# Square Denims Limited (Garments Unit) (Extension)

Dubaliapara, Zamirdia, Bhaluka, Mymensingh

## Structural Inspection Report

### SMF detailing checks provided in the design report

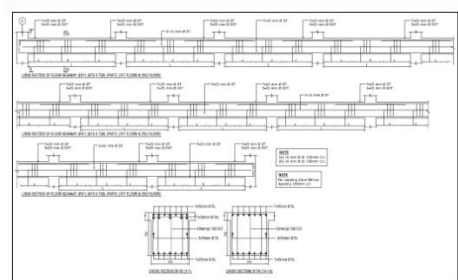
**Description:** The building engineer has prepared the design report based on Special Reinforced Concrete Moment Frames (SMF). However, several key detailing checks have not been adequately addressed in the report as per BNBC 2020 Part VI, Section 8.3.

The building engineer must ensure the check in compliance with all SMF detailing requirements outlined in BNBC 2020 Sections 8.3.4, 8.3.5, 8.3.7, 8.3.8, and 8.3.11. These checks should be verified and incorporated into the design report to ensure full alignment with the code provisions.

**SMF detailing checks in the design report**

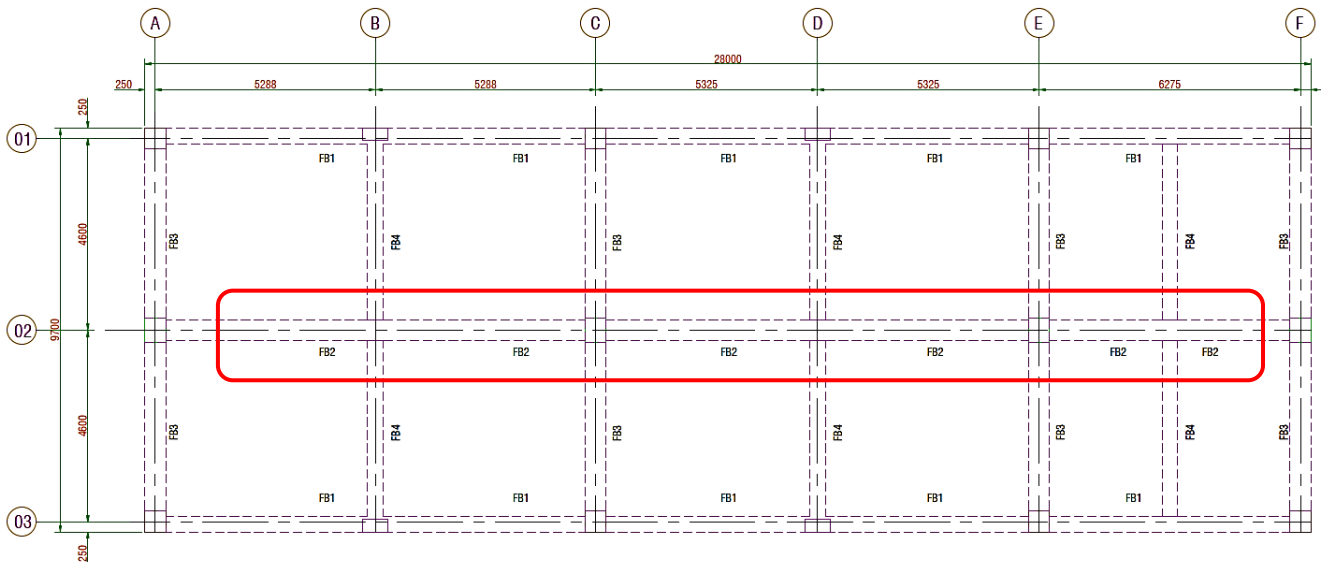
**Description:** The building engineer has prepared the design report based on Special Reinforced Concrete Moment Frames (SMF). However, several key detailing checks have not been adequately addressed in the report as per BNBC 2020 Part VI, Section 8.3. Apparently the two-storied ETP building has irregular shape. In the irregularity check section, the building engineer has not incorporated all horizontal and vertical irregularity checks as BNBC 2020 Table 6.1.4 and 6.1.5. The building engineer must ensure the check in compliance with all SMF detailing requirements outlined in BNBC 2020 Sections 8.3.4, 8.3.5, 8.3.7, 8.3.8, & 8.3.11 and all irregularities checks as per BNBC 2020 section 1.3.4.2. These checks should be verified and incorporated into the design report to ensure full alignment with the code provisions.

LONG SECTION OF FLOOR BEAM-FB2 (500 X 750)~(500 X 600)

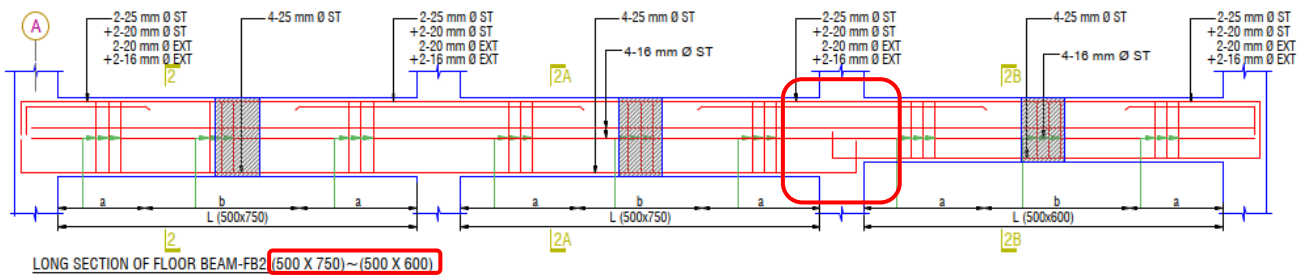
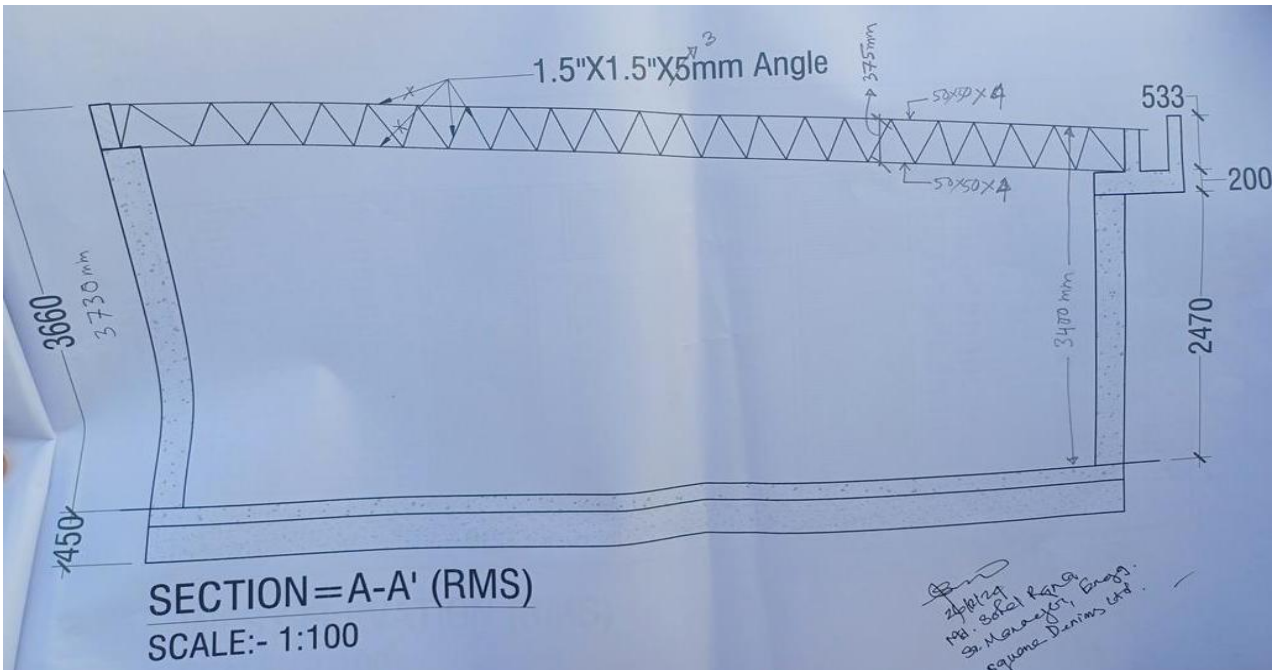
**Description:** During inspection, mismatch was found between the provided as-built drawing and actual site condition. The depth of the roof beam FB2 was found 500 X 600 instead of (500 X 750) in two spans. The building engineer is required to survey the structure and update the accurate as-built drawing as per actual site condition.
